ABINGTON TOWNSHIP

BOARD OF COMMISSIONERS WORKING SESSION

b. Motion to approve the Preliminary/Final Land Development - LD-22-06 - 2620 West Moreland Road (Raising Cane's).

SHEET NUMBER:
C1.1
2 OF 26

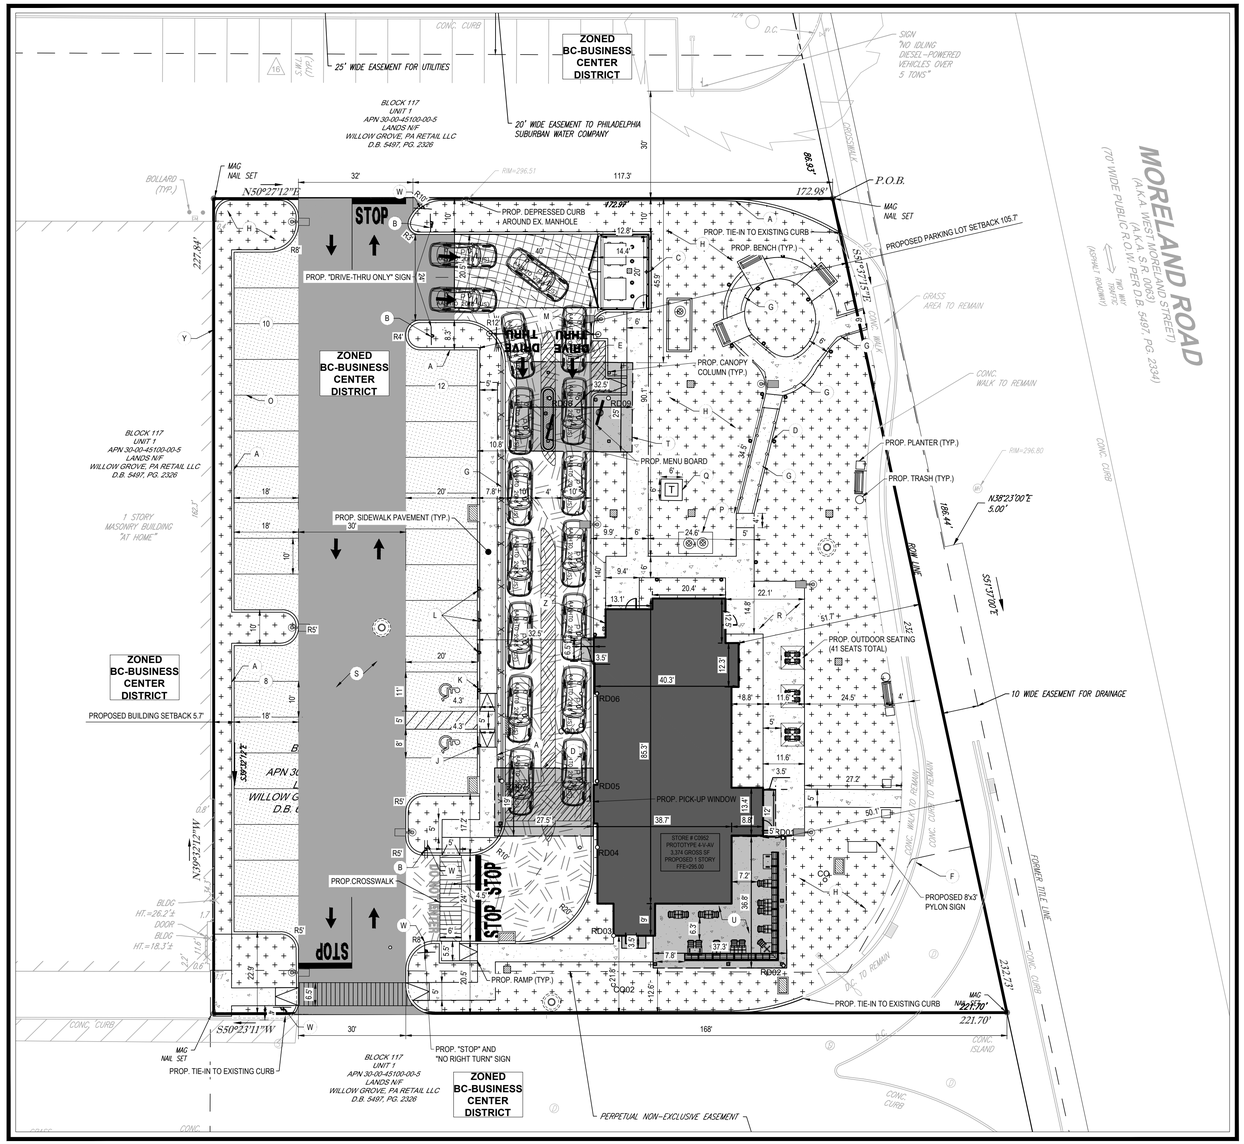
On the Record Plan (Sheet C1.1) it is noted to refer to the architectural plans for details of the screening, gates, bollards, and masonry for the trash enclosure however the details shall also be provided on the Land Development Plans. A trash enclosure detail shall be provided on the plans which shows the height and material of the proposed enclosure.
    In accordance with Zoning Hearing Board Application #23-11, the Applicant is requesting a variance from this Code Section to permit outdoor trash containment facilities to not utilize self-closing gates.

Response: A crosswalk, designed to Abington Standards, has been implemented at the drive access. Please see Sheet C1.1.

Response: Parking has been revised to match Abington Township dimension standards. Please see Sheet C1.1.

Response: Table has been revised to show the corrected height of 20’. Please see Sheet C1.1.

Response: The outdoor tables are fixed to the ground, and the chairs will be secured after normal operating hours. A note has been added to sheet C1.1.

Response: A note has been added to sheet C1.1.

SHEET NUMBER:
C1.1
2 OF 28

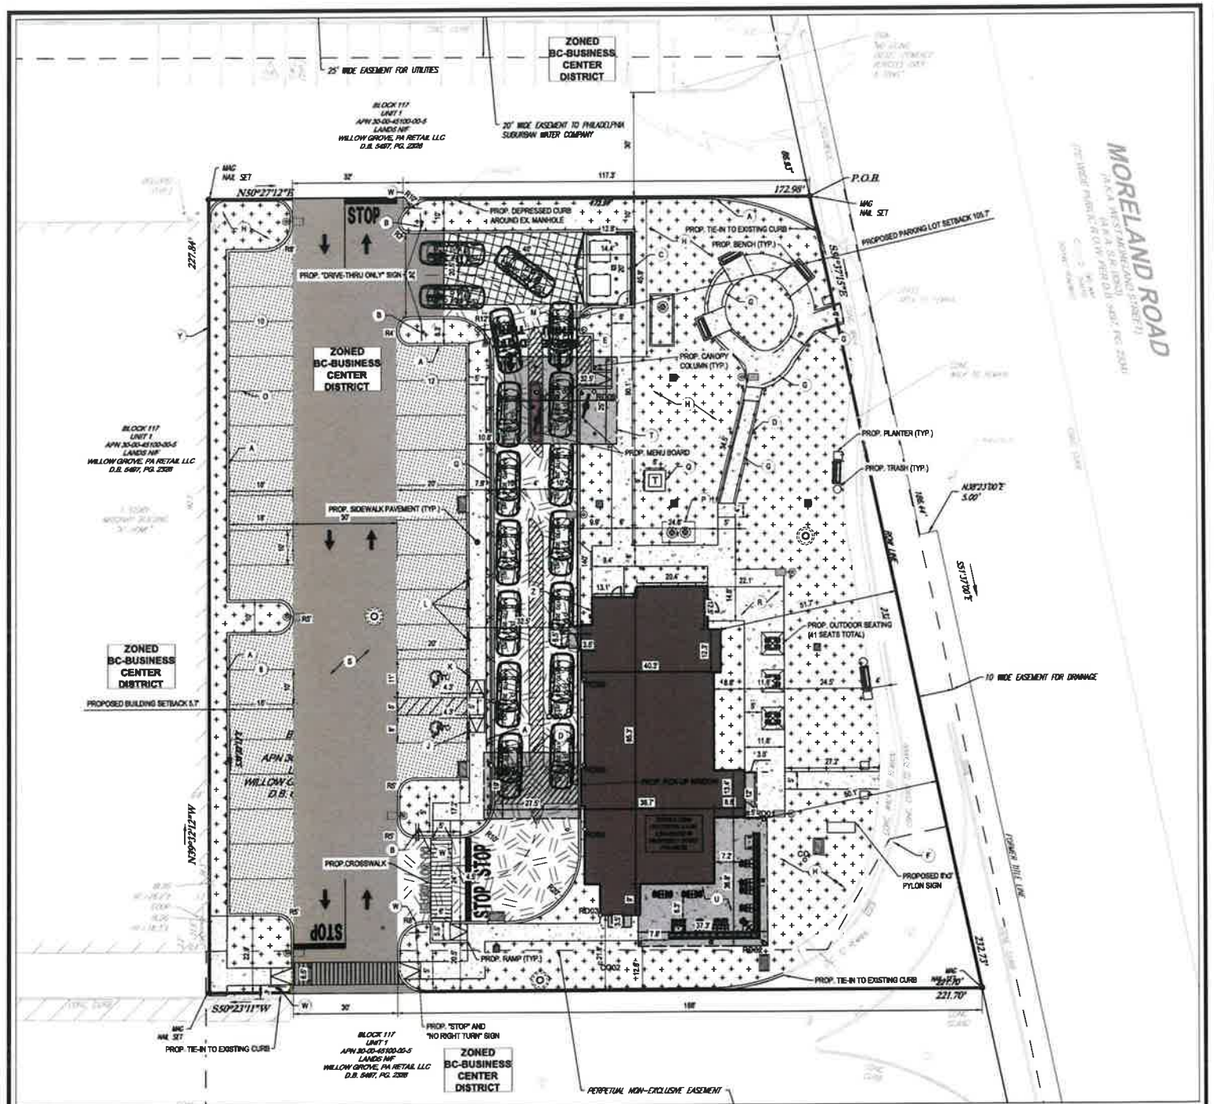
On the Record Plan (Sheet C1.1) it is noted to refer to the architectural plans for details of the screening, gates, bollards, and masonry for the trash enclosure however the details shall also be provided on the Land Development Plans. A trash enclosure detail shall be provided on the plans which shows the height and material of the proposed enclosure.

Response: The zoning chart on the Record Plan C1.1 is revised to list the Parking Use requirements A-17.

Response: The zoning chart on the Record Plan C1.1 is revised to list the Parking Use requirements C-25.

Sidewalk and crosswalk along Southern secondary access drive has been added to Plans. Please see Sheet C1.1.

Response: Noted. The building setback lines and build-to lines are shown on sheet C1.1

Response: Parking Spaces have been revised to meet 146-28.A parking requirements. See Sheet C1.1. Parking spaces adjacent to building shown as 10' by 20'. Parking spaces to the west of the drive aisle shown as 10' by 18' due to the 2' overhang in the landscape area.

SHEET NUMBER:
C4.0
8 OF 26

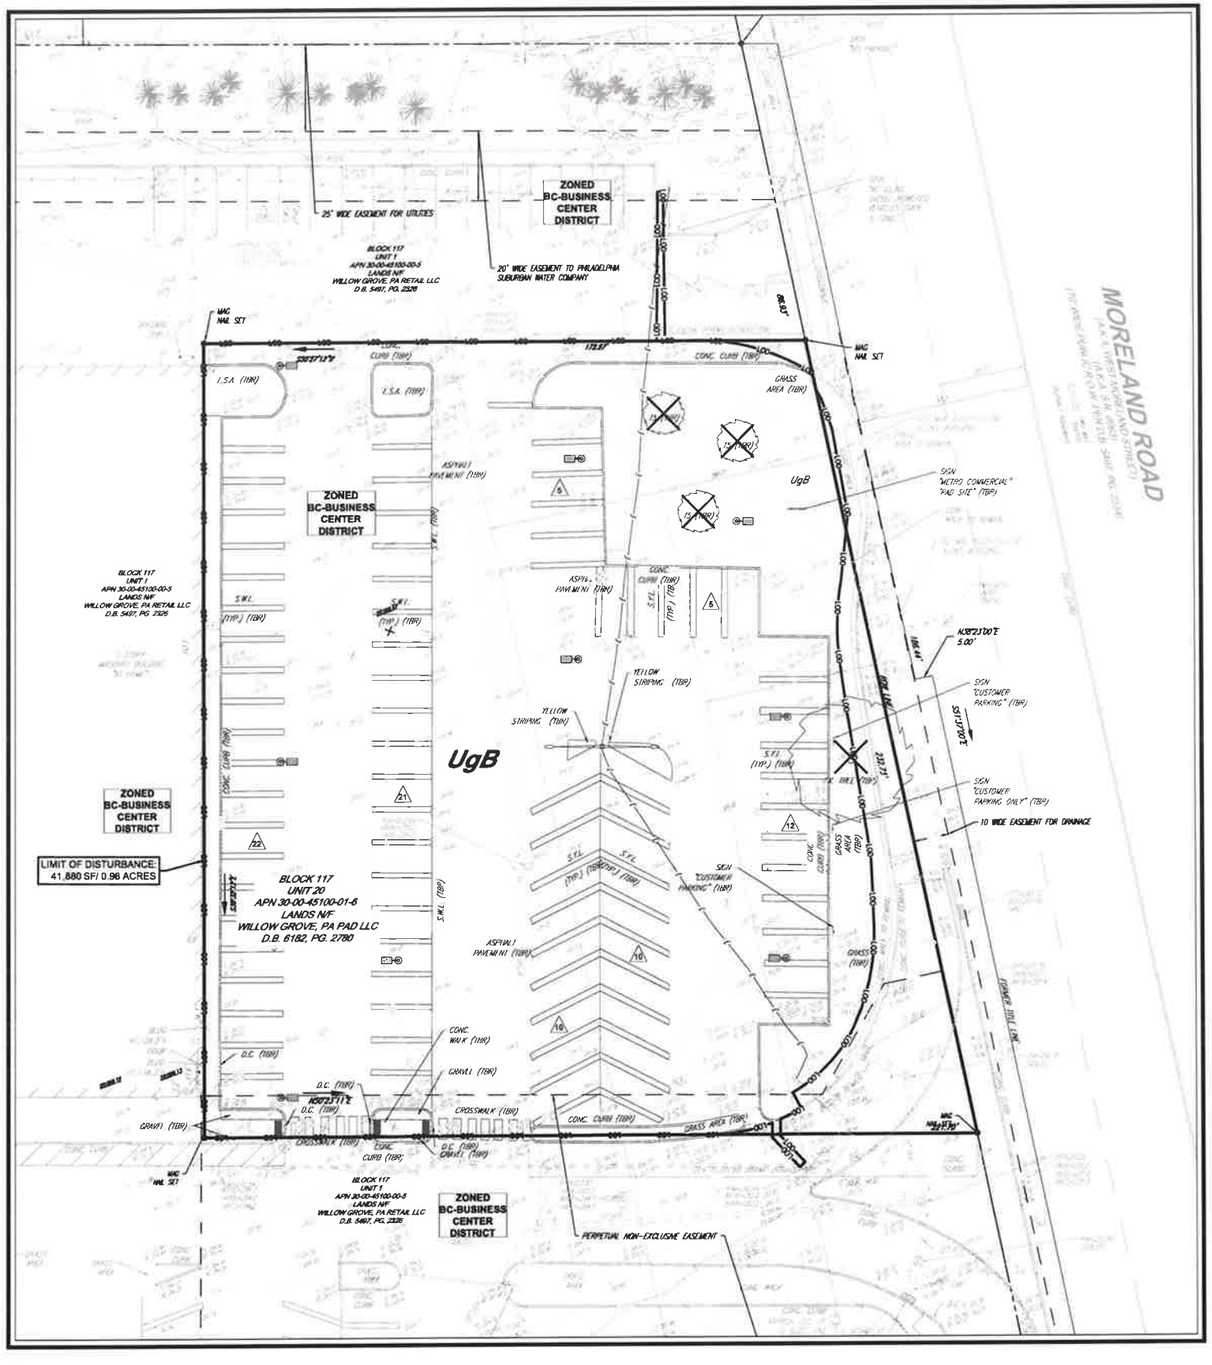
39. Per §146-11.B.(8).(b) & §146-11.D.(4) – Existing Features Plan & Grading Plan – The existing features plan shall contain the datum to which contour lines refer. This note shall be provided on the Existing Conditions plan (Sheet C4.0) and grading plan (Sheet C6.0) per Section 146-11.D.(4).

Response: Cartway width for West Moreland Road has been added to Sheet C1.1 and C4.0.

Response: Requested labels have been added to Sheet C1.1 and C4.0.

Response: Note stating "Existing Contour Information are based on the NAVD88 Datum" has been added to Sheets C4.0 and C6.0.

Response: Soil Map and Soil Limitations and Their Resolutions have been provided on Sheet C3.1 due to spacing on Sheet C4.0 (Existing Features Plan). Note added to the C4.0 stating the Soil Type and referring to C3.1 for Limitation Notes.

SHEET NUMBER:
C5.0
10 OF 28

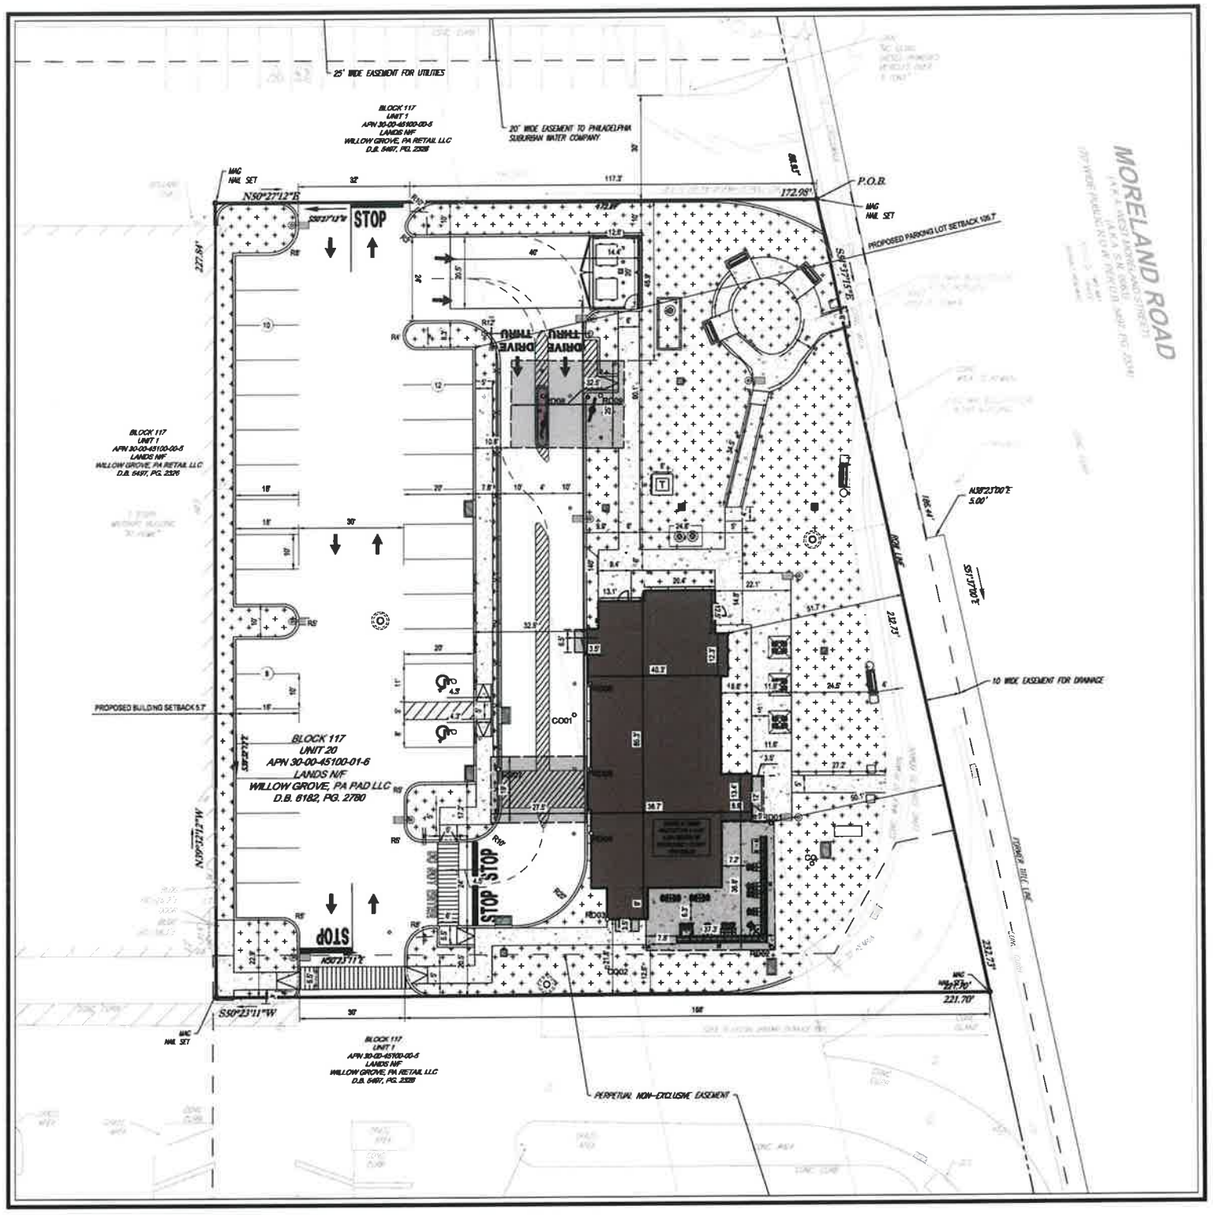
Response: The site constraints result in not enough space for a bio retention. The project is sheet flowing impervious areas to green areas as shown on the grading plan, sheet C6-0.

Response: Sheet C6.0 shows the Limit of Disturbance Line/ NPDES Disturbance Area. Please see the Legend. The Area is less than one acre, therefore an NPDES permit will not be required.

Response: Curb ramps have been proposed where the sidewalk crosses the southern access drive aisle. Please see Sheet C6.0.

SHEET NUMBER:
C7.0
17 OF 26

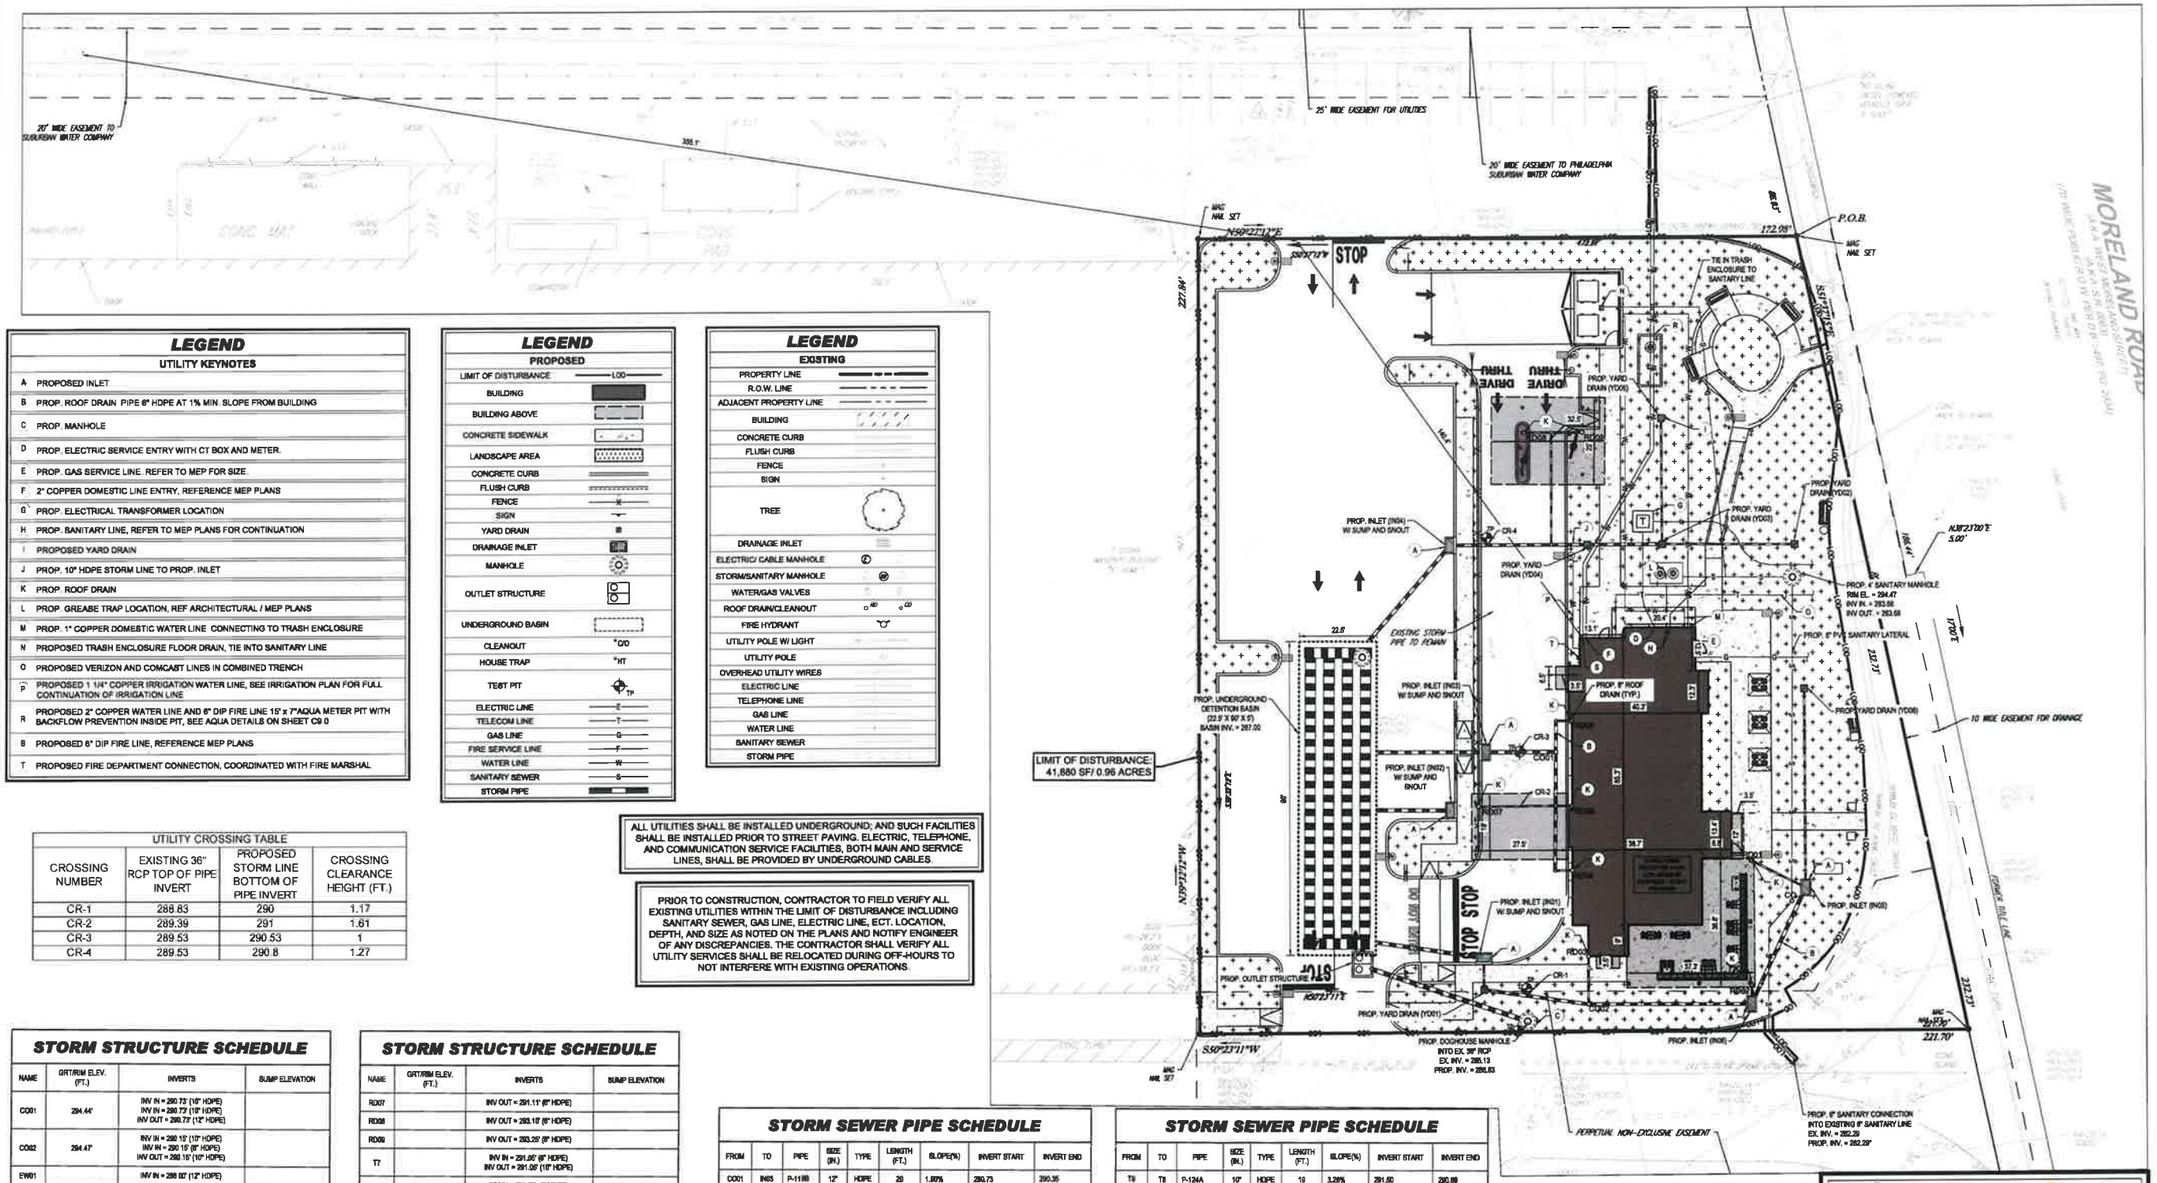
5. Would the applicant clarify drainage for the trash enclosure area for the restaurant? On sheet C7, Utility Plan, the legend indicates that the trash enclosure floor drain ties into the storm sewer system, but the plan indicates tie-in to Sanitary Sewer. We recommend that this be tied to Sanitary Sewer line to capture any pollutants that might run off from trash enclosure areas, especially since this area is not covered.

Response: This was a typo, the Trash enclosure floor drain is to tie into the sanitary sewer. Please see Sheet C7-0.

Response: Please see Sheet C7.0, which has been revised to show an existing Fire Hydrant located within 500' of the building. Proposed Fire Department Connection shown on plan with label "T".

Response: Note has been added to Sheet C7.0.

SHEET NUMBER:
C10.0
23 OF 26

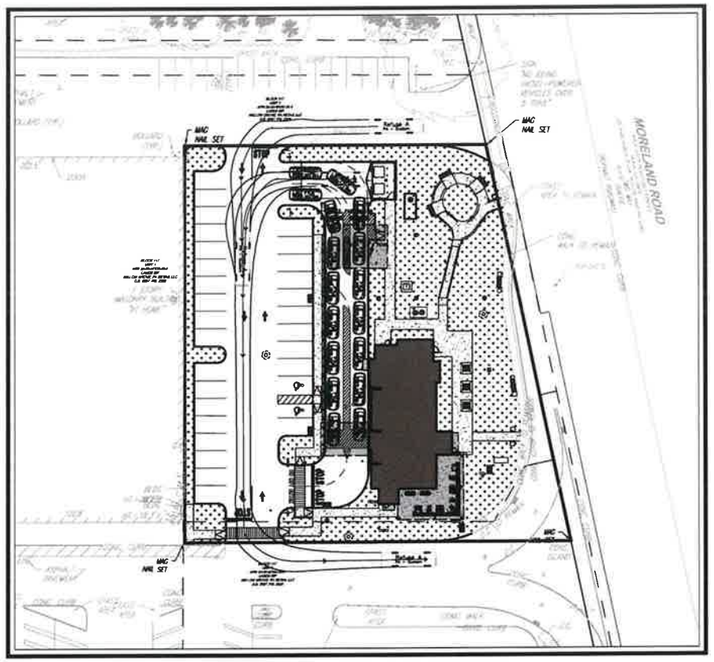
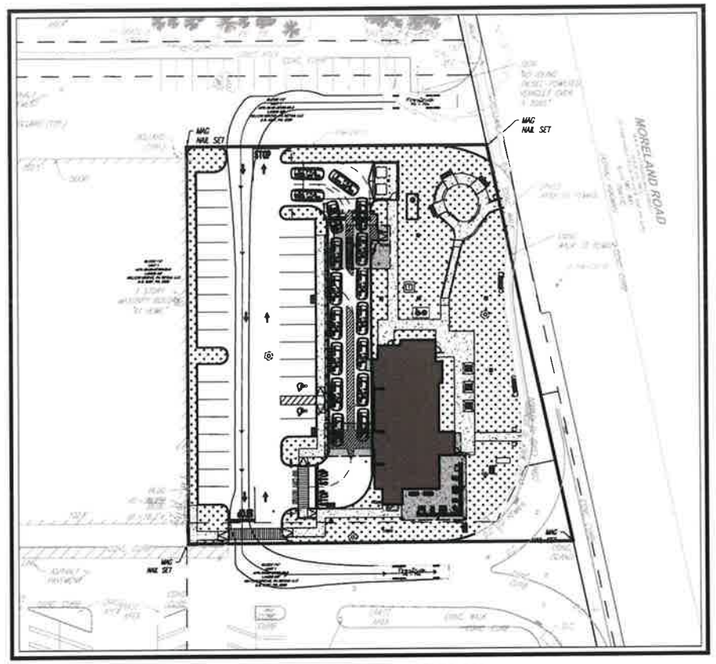
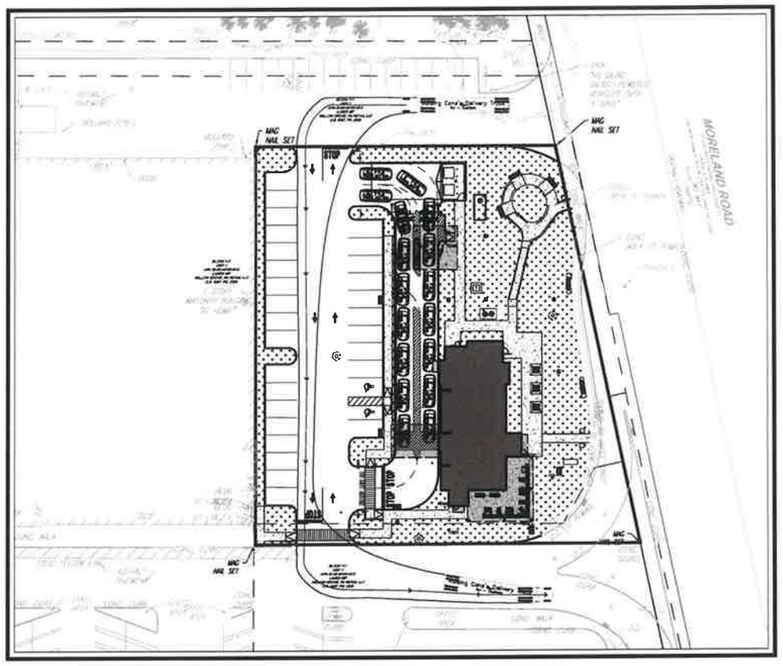
18. Per §2312.A thru K – Off-Street Loading Requirements – There is no loading berth/area shown on the plans. Since the proposed fast-food restaurant will be receiving deliveries of food and supplies to the site, a loading berth/area shall be provided. The plans shall indicate where the loading berth/area will be provided on the site. The loading berth/area shall adhere to the requirements of this Code Section. Per Figure 23.2, the fast-food restaurant is classified as an other use and is required to have 1 loading berth/area for the first 20,000 SF of gross floor area.

Response: Raising Canes deliveries will occur during off hours when the store is closed, therefore a dedicated loading space is not needed. Refer to the Vehicle circulation plan , sheet C-10 showing the delivery truck movement as well as a note indicating "deliveries to occur during off hours when store is closed"

Response: Raising Cane's deliveries will occur during off hours when the store is closed, therefore a dedicated loading space is not needed. Refer to Vehicle circulation plan, Sheet C-10 showing the delivery truck movement as well as a note indicating "deliveries to occur during off hours when store is closed".
